## WIZARD WORKSHOP ARTICLES

PRODUCT

1502

Pulser/Sampler 1A

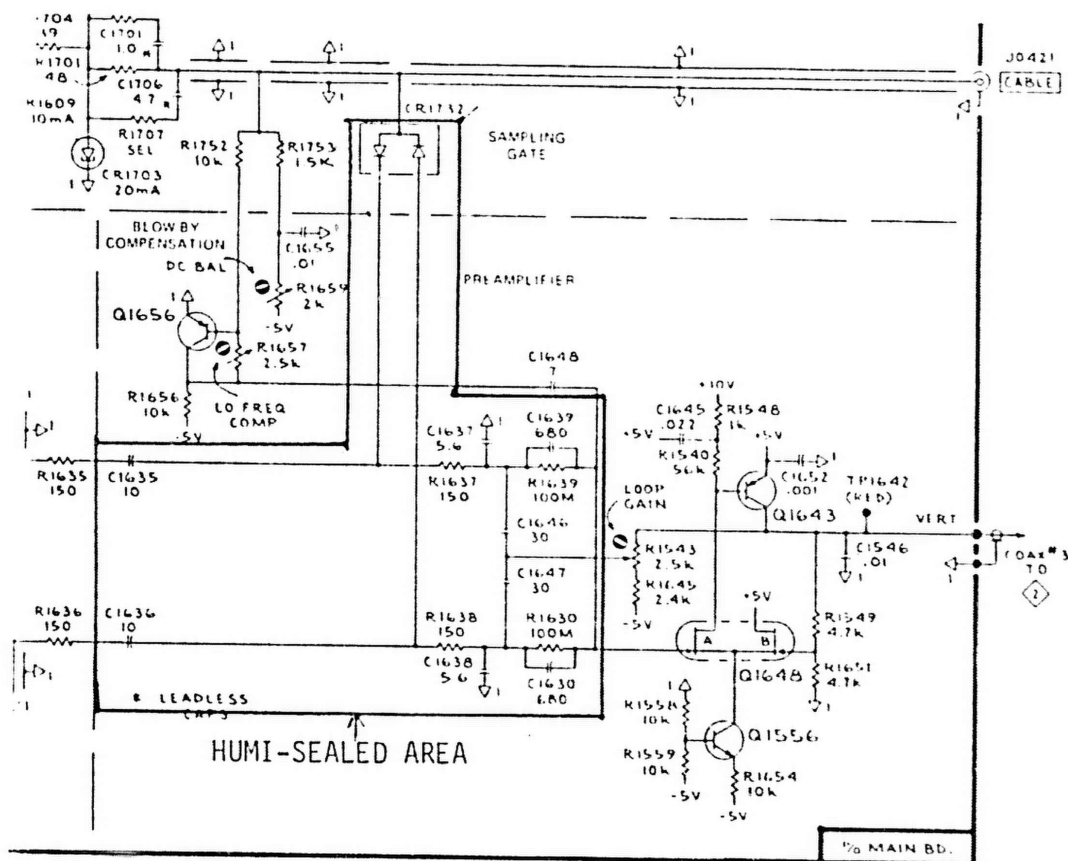
To prevent humidity or moisture from degrading resistors or causing aberrations some parts are coated with humi-seal at the factory.

Whenever this coating has been impaired in any way it should be renewed.

Following are the coated components:

C1630	R1630
C1635	R1637
C1636	R1638
C1637	R1639
C1639	CR1732, Bridge
C1646	Also the FET (01648) base
C1647	on the solder side of the
C1648	board is sealed

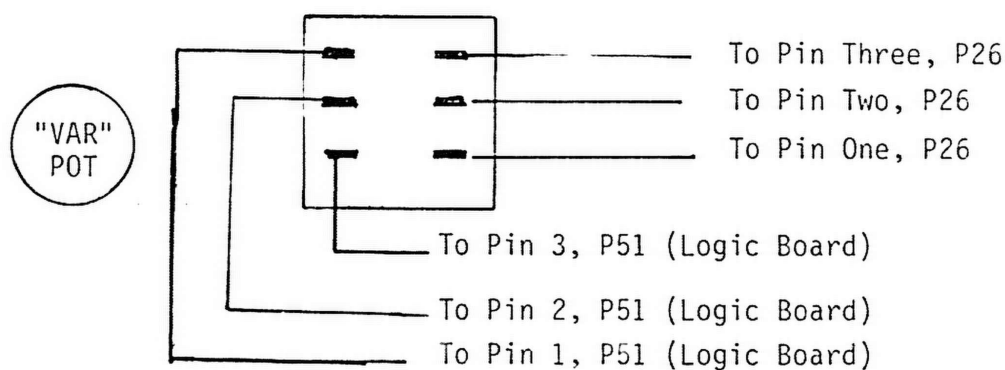
The following changes are necessary to reactivate the camera function:

1. Remove two bare hard wire straps from back of camera switch.
2. Remove wire (red-black) from center pole and resolder to the center pole on the other half of the switch.
3. Eight inches of three strand ribbon wire, with square pin co-nectors, 131-0707-00 connectors on wire and three pin "Harmonica" 352-0161-XX (00 through 06 is ok) is needed.
4. Locate square pins marked "P26" on Vertical Amp/Slow Ramp board.
5. Remove short between pins 2 & 3 of P26. Also remove excess solder.
6. Connect harmonica connector to P26 and feed wire through mainboard. (next to wiring from "zero reff" pot and P27 on vertical amp board). Removal of X-Y module or chart recorder will help.

CAMERA FUNCTION DELETED

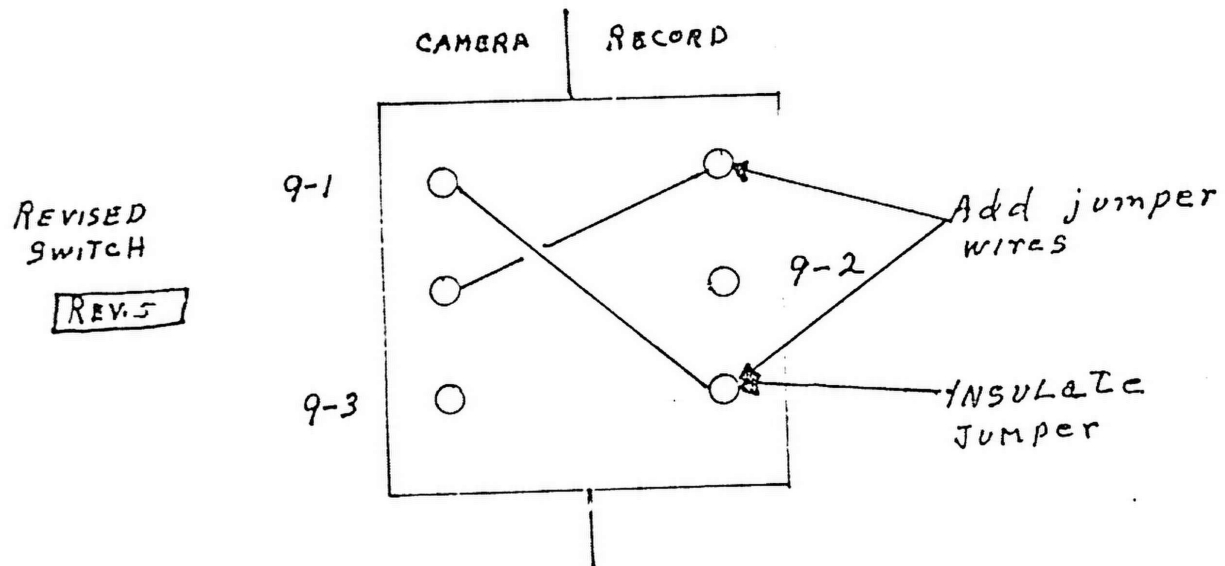
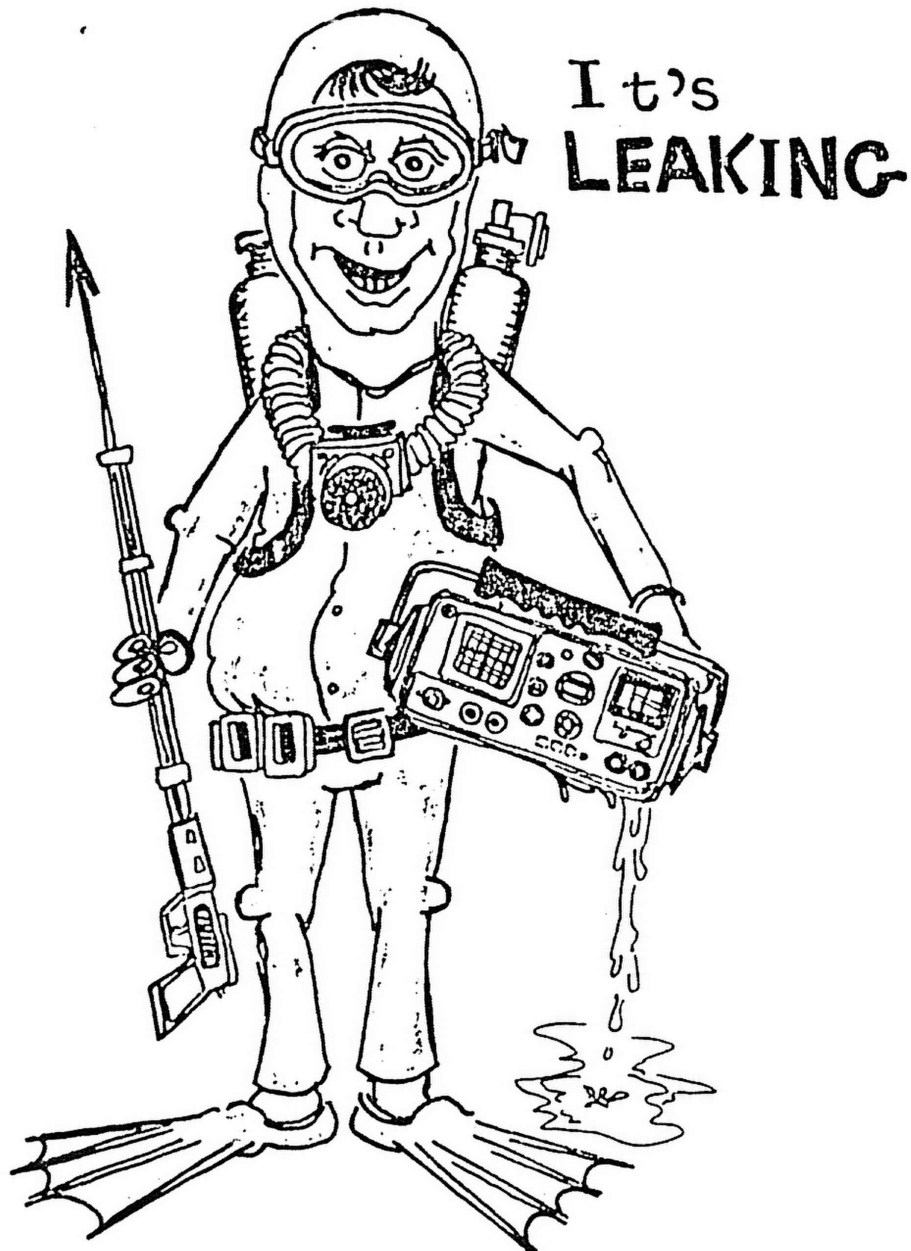
Now that the dust has settled, further explanation is in order. The camera function has been deleted from the 1502 and 1503 due to low usage and a patent problem in Japan. The incorporation of this deletion has caused some misunderstanding and inconvenience. There are ~120 1502's and 220 1503's in which the function was deleted, but not the word "camera" from the front panel. Some have new front panels with "Camera", some have "Camera" covered with a sticky back tag.

CHART RECORDER  
670-1742-04

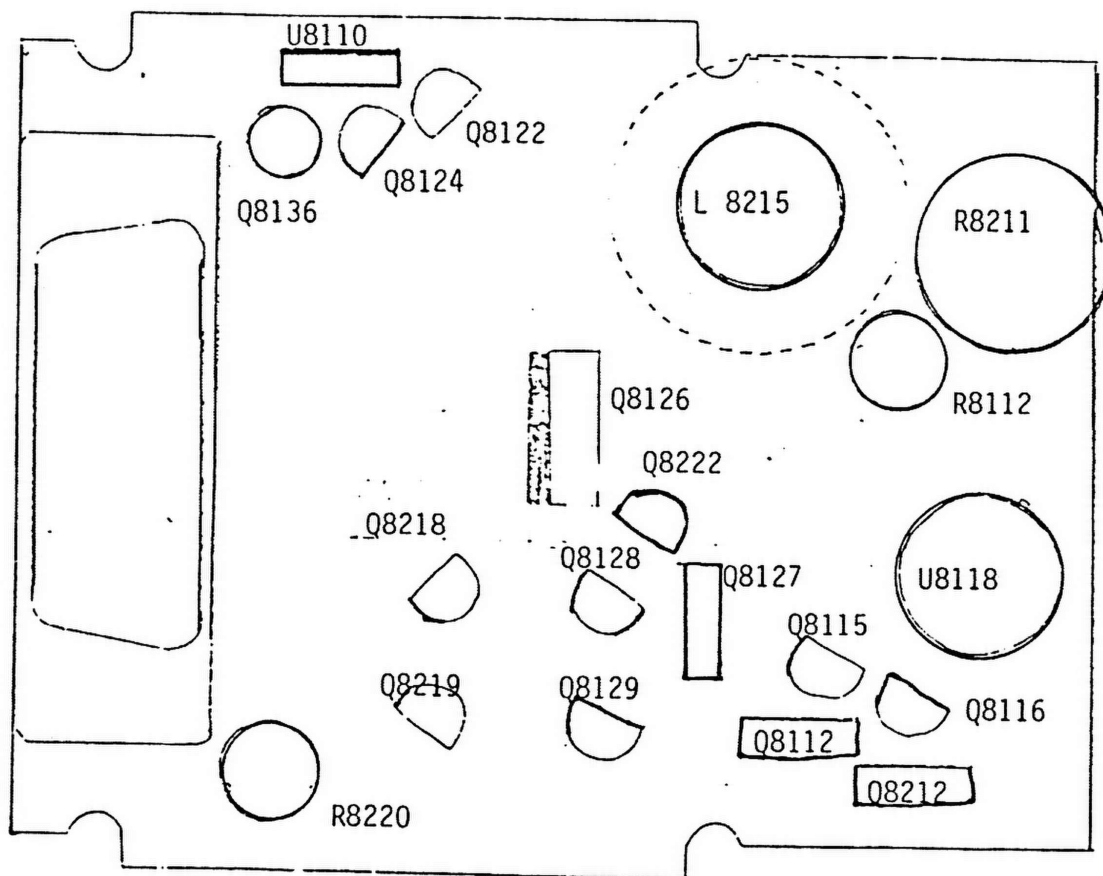
The 1502 and 1503 chart recorder circuit board 670-1742-03 has been relayed out. It is now 670-1742-04. Following is the new semiconductor location. I recommend ordering a new manual.

## DAMPENER COMBO

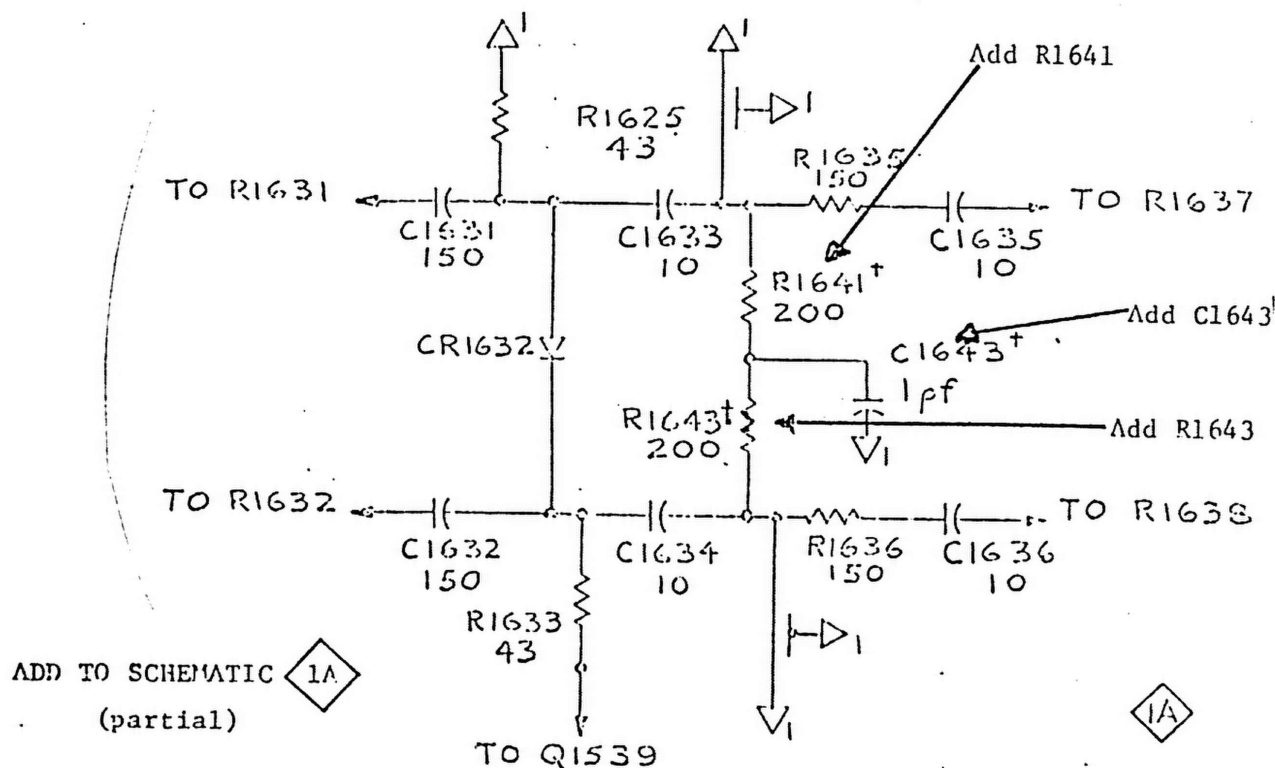
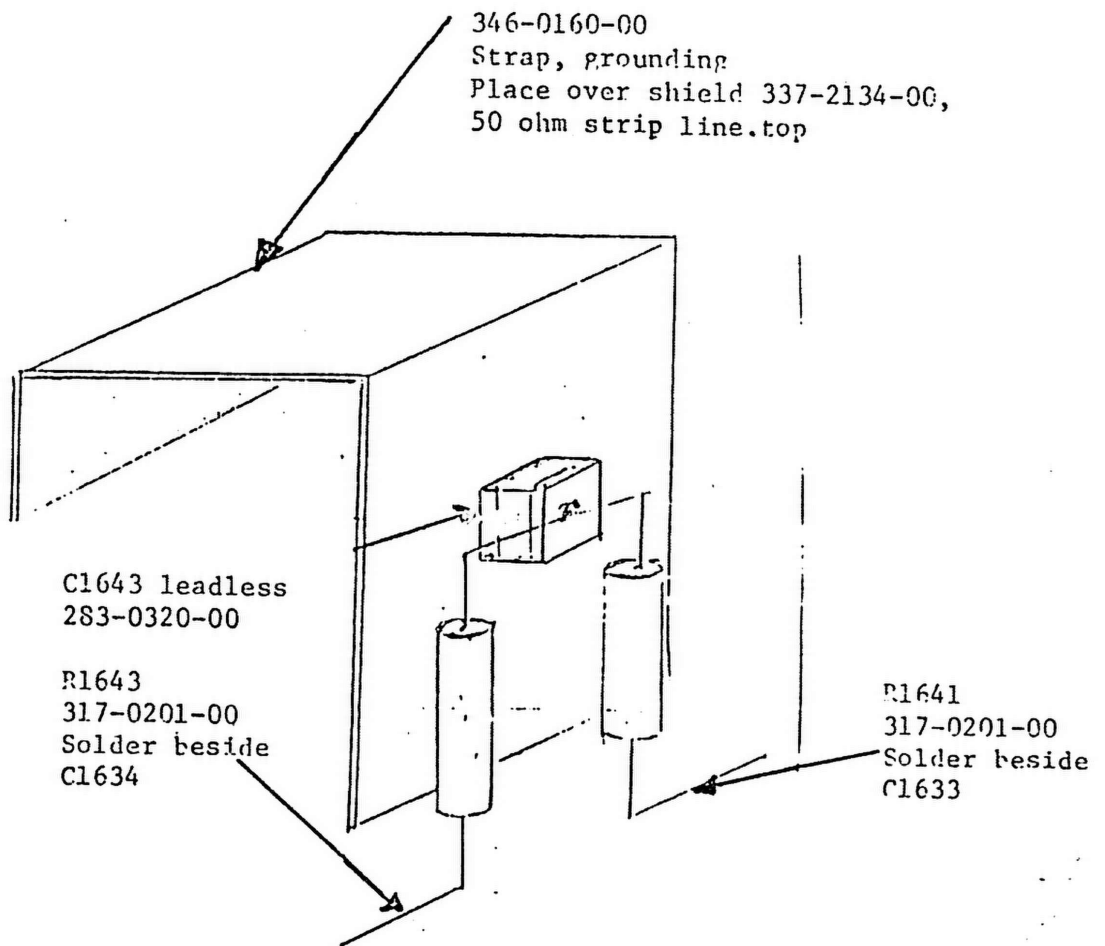
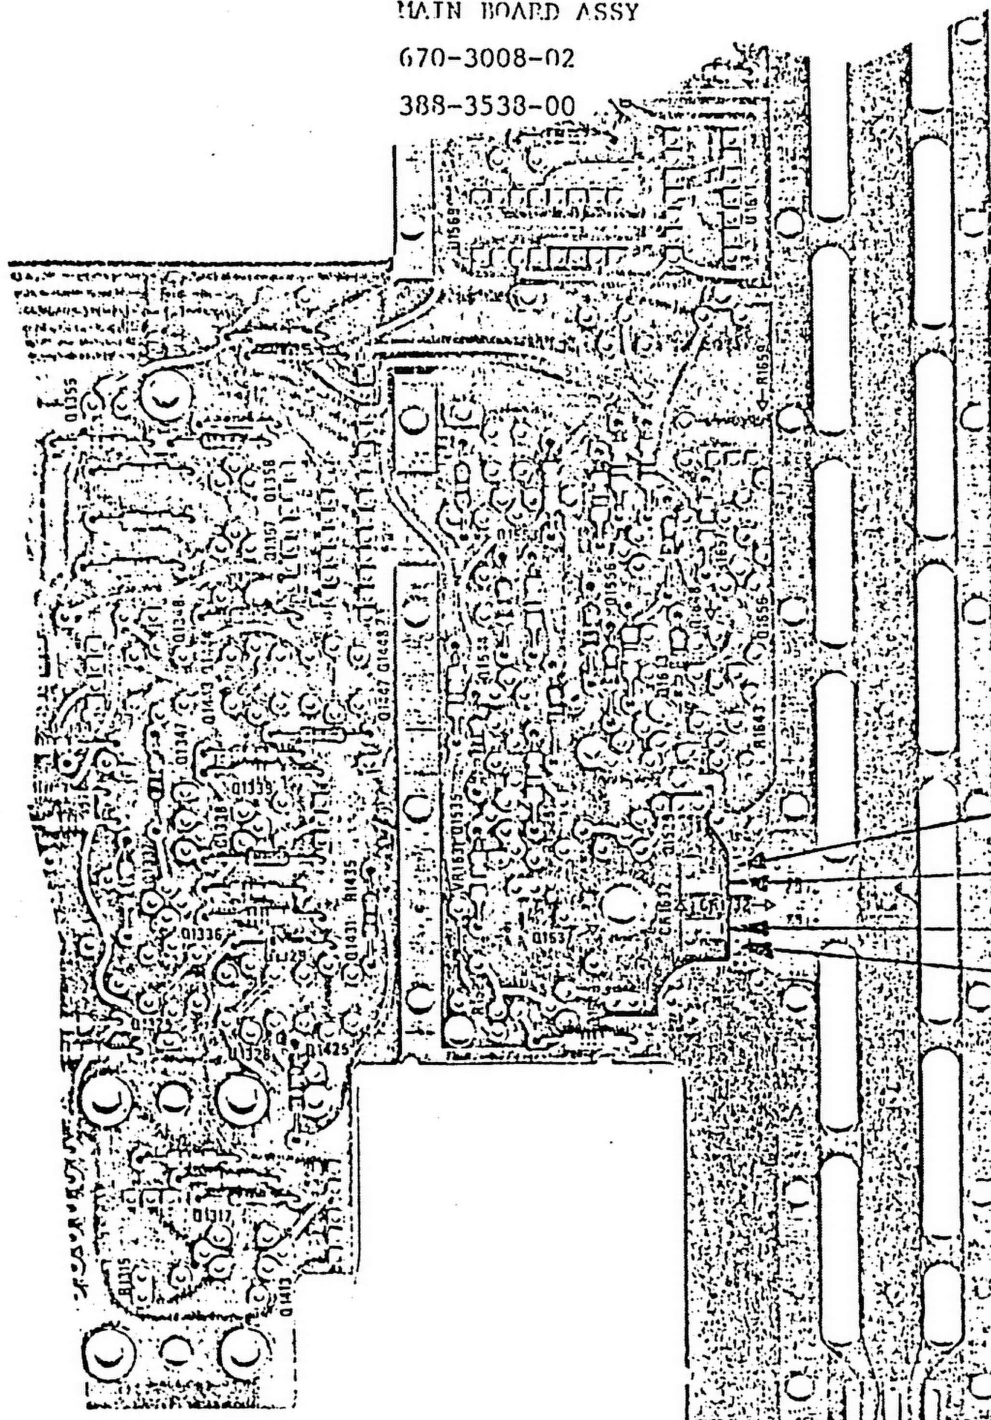
DESCRIPTION OF CHANGE: add a test selected damper, when needed, that will attach to stripline cover and to 10pF leadless caps & 150 $\Omega$  resistors (C1633, R1635 and C1634, R1636 connections).

Dampener is made with R1641, R1643 317-0201-00, C1643 283-0320-00 and grounding strap 346-0160-00. Located on Main Bd. Ass'y 670-3008-02. See drawing and schematic.

Add test selected Dampener Ckt. (when need) consisting of the following Comp.
